James A. FitzPatrick Nuclear Power Plant
Renewed Facility Operating License No. DPR-59
NRC Docket No. 50-333

Subject: Response to Request for Additional Information in support of License Amendment Request – Proposed Changes to the Technical Specifications to Primary Containment Hydrodynamic Loads

Response to FitzPatrick request for additional information: Amendment Request for Change to the Technical Specifications to Revise the Allowable Value for Reactor Water Cleanup (RWCU) System Primary Containment Isolation (EPID: L-2019-LLA-0190)

Exelon Generation Company LLC
James A. FitzPatrick Nuclear Power Plant
Short-Term Containment Analysis for Zero
Drywell-to-Wetwell Pressure Differential

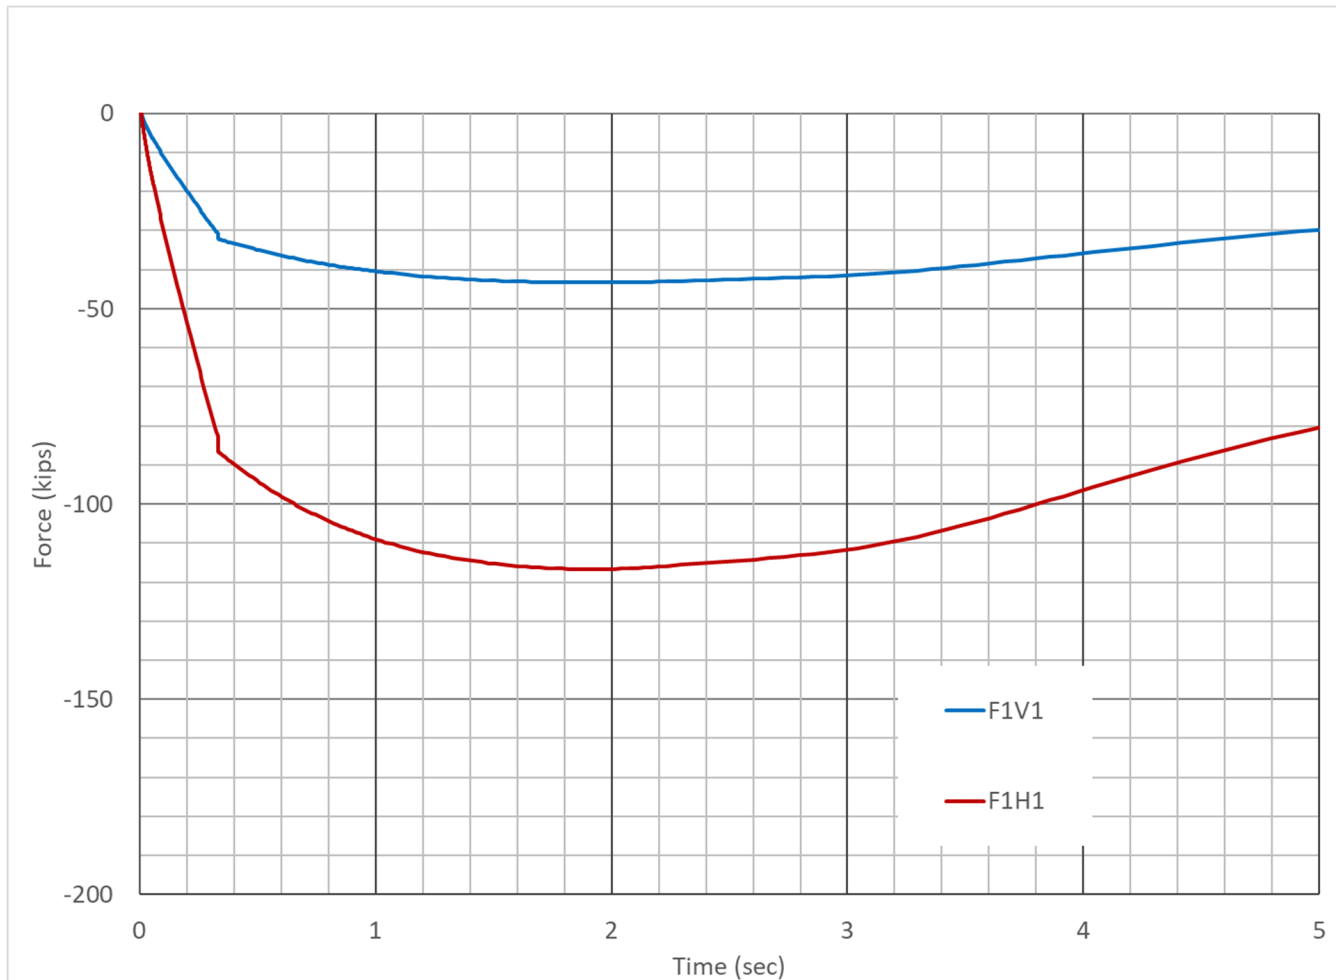
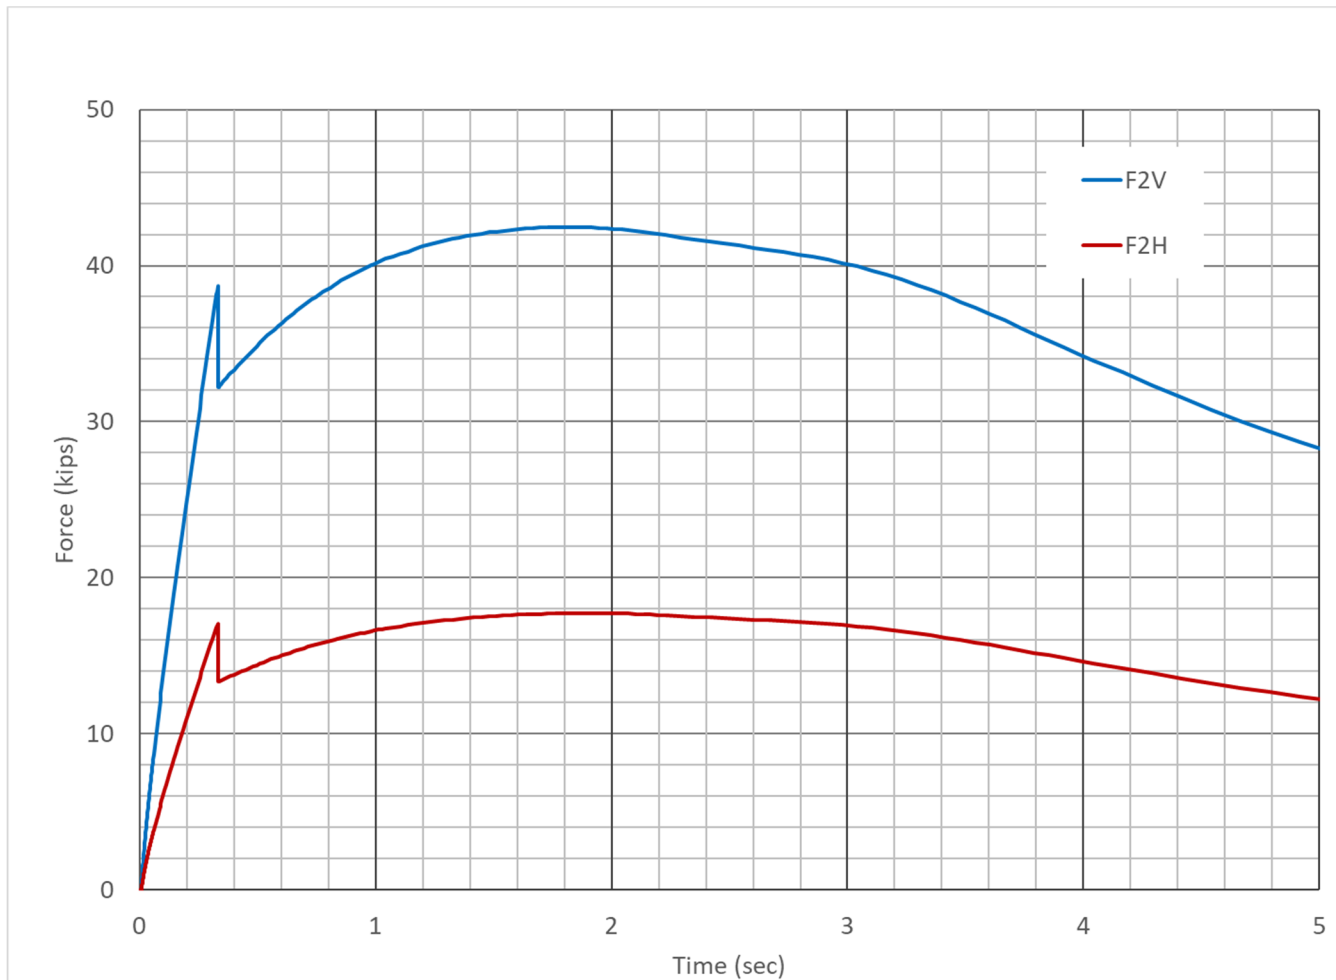
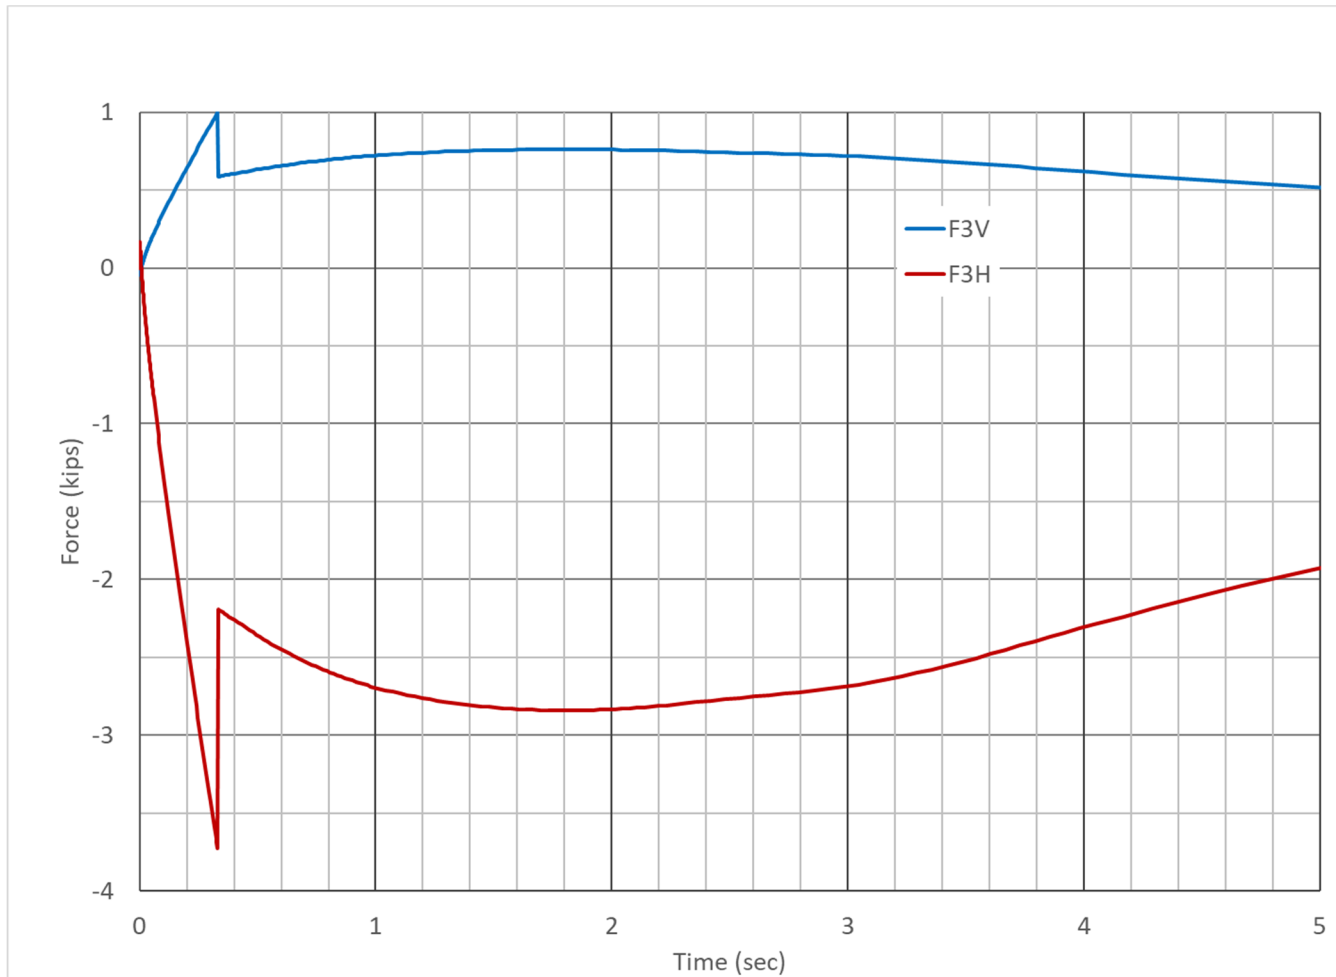
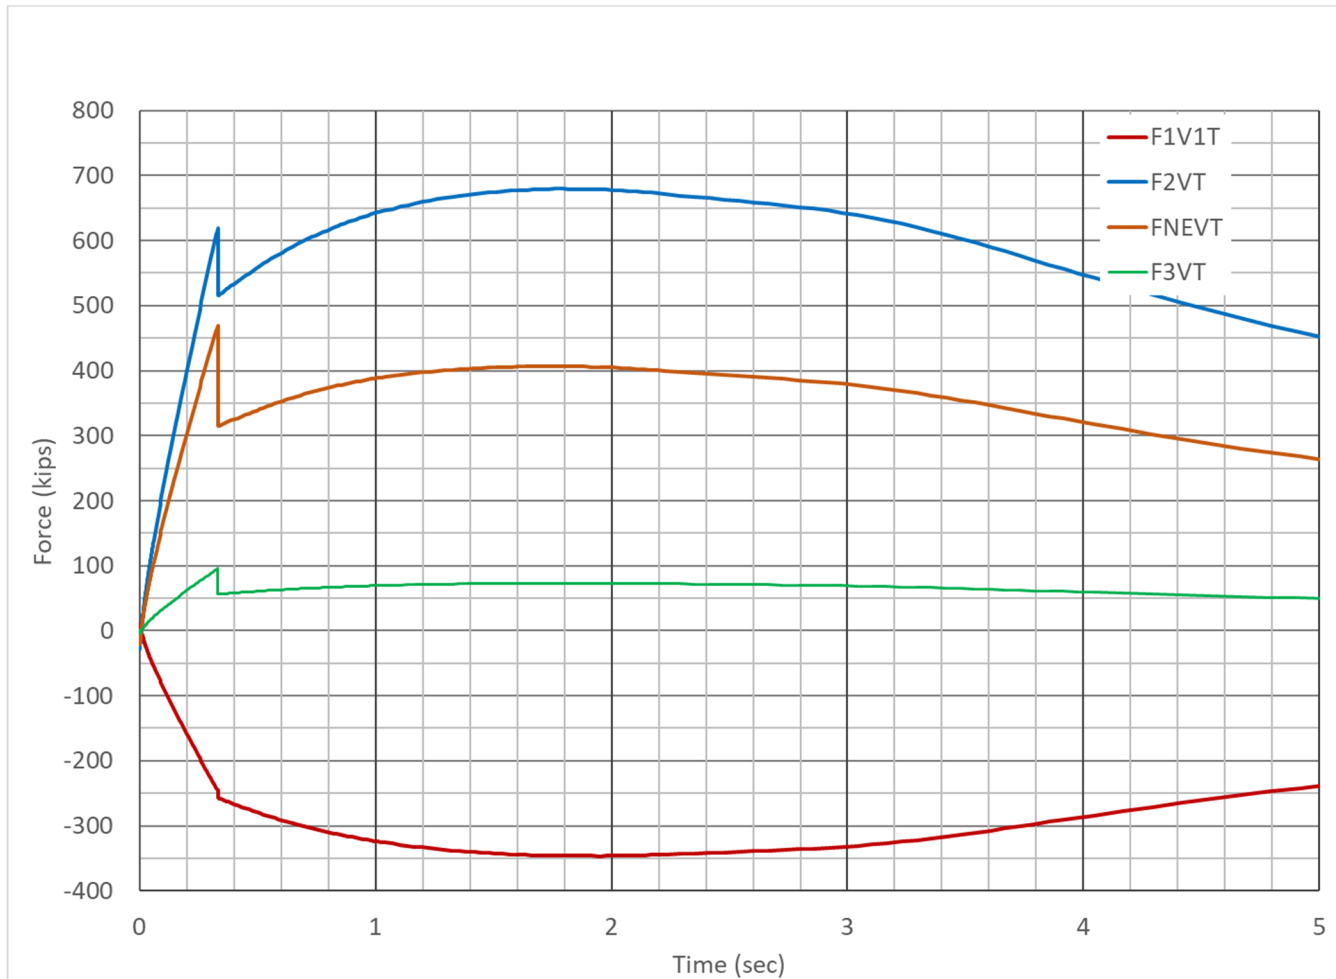
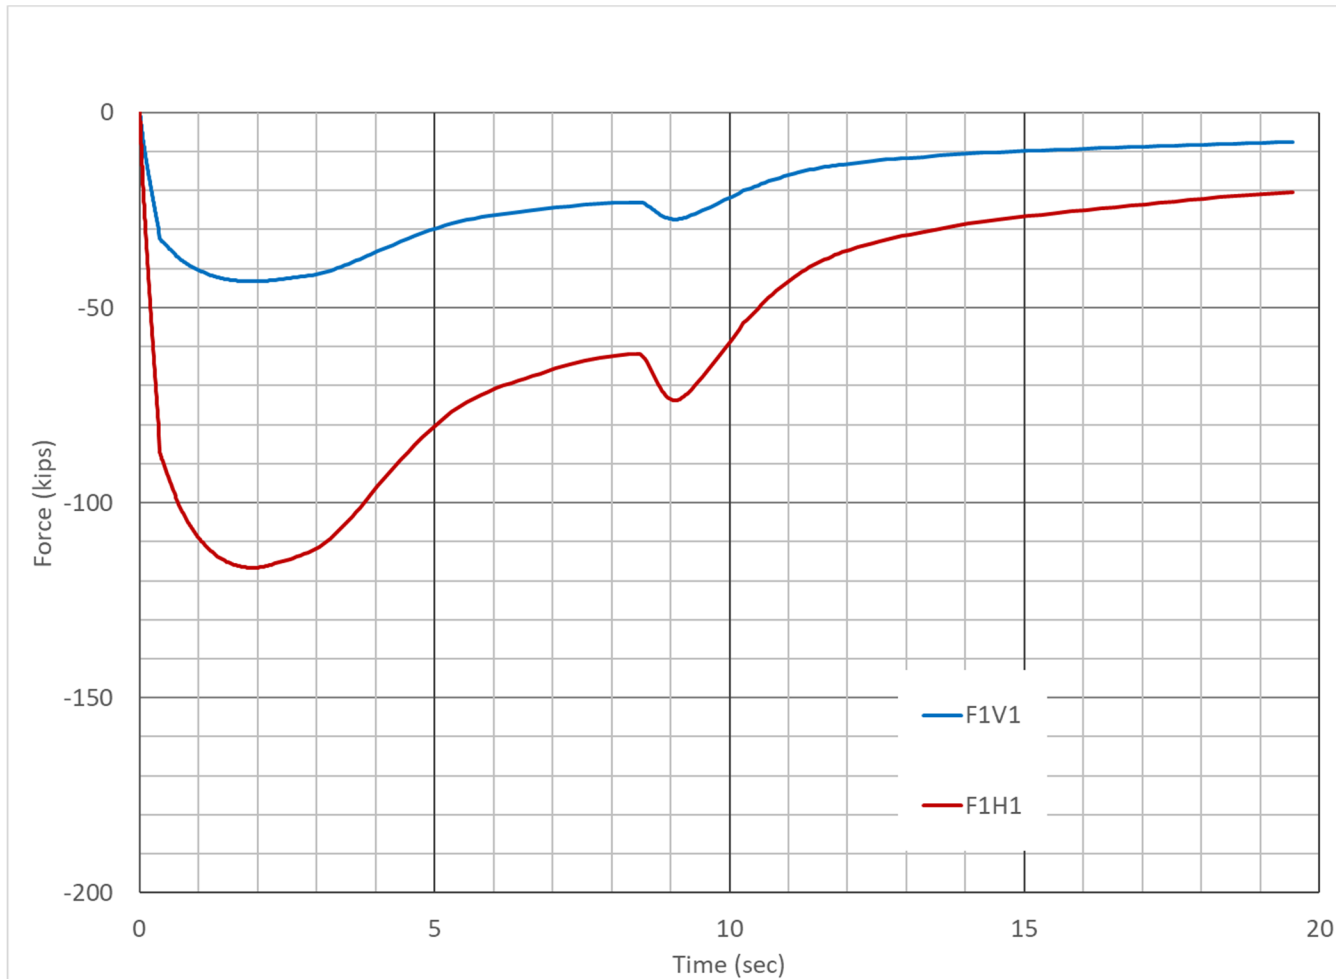
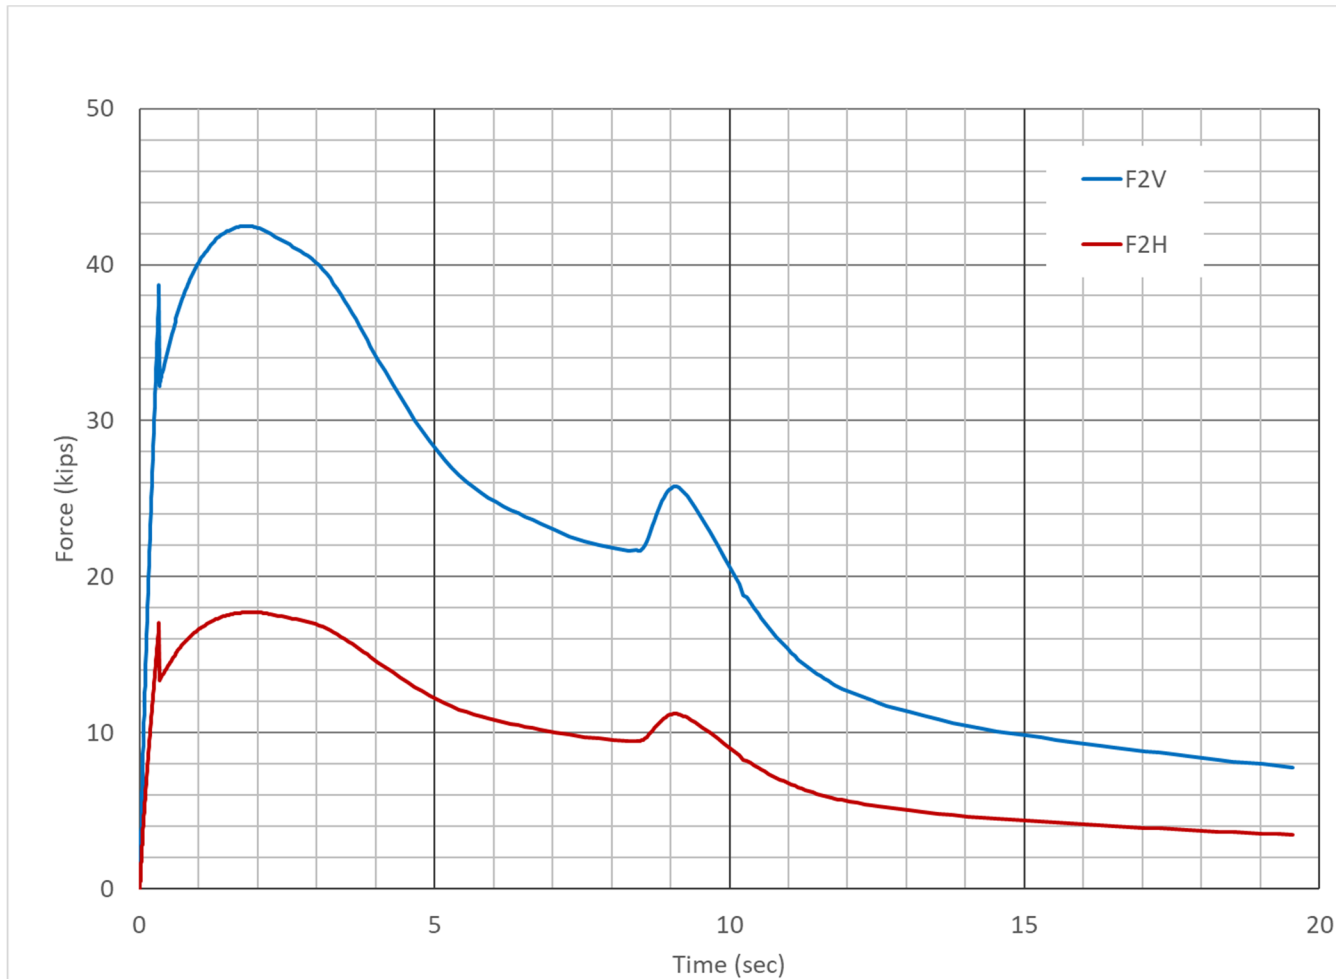
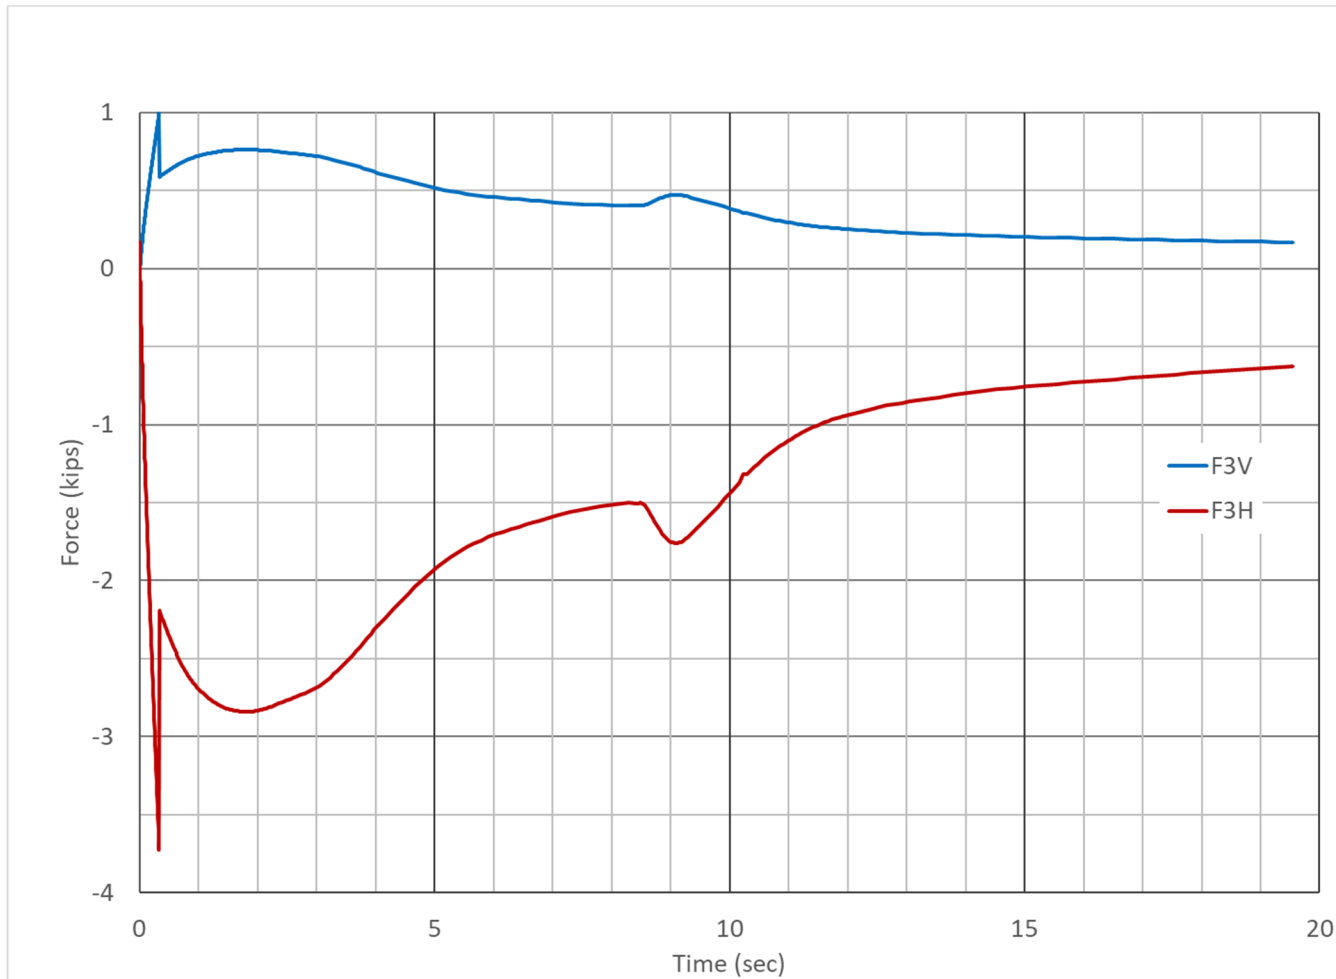
- (c) Based on the proposed TS changes, provide bounding values of the vent thrust loads based on which the structural analysis given in Attachment 6 of the LAR is performed.

- (a) Assessment of these loads based on the revised containment pressure and temperature response can be found in Section 4.0 of 005N1724 (Attachment 2 of this letter).
- (b) The most limiting pressurization rate based on the proposed TS change can be found in Section 4.1 of 005N1724. The maximum pressurization rate as found in section 4.1 of 005N1724 bounded by the full-scale drywell pressurization rate of 60.48 psi/s.
- (c) Bounding values of the vent thrust loads are provided in Table 2 of 005N1724. The structural evaluation given in Attachment 6 of the LAR considered these loads in Section 5.2.4.

The comparisons in Table 2 show that the vent thrust loads for the downcomer mitre bend (F3V, F3VT and F3H) exceed the current design and licensing basis loads. All other loads are still less than the loads in the Plant Unique Load Definition report for operating ΔP .

The vent thrust loads are plotted in Figure 1 through Figure 8. The pressure histories used in calculating the vent thrust loads are plotted in Figure 9 and Figure 10.
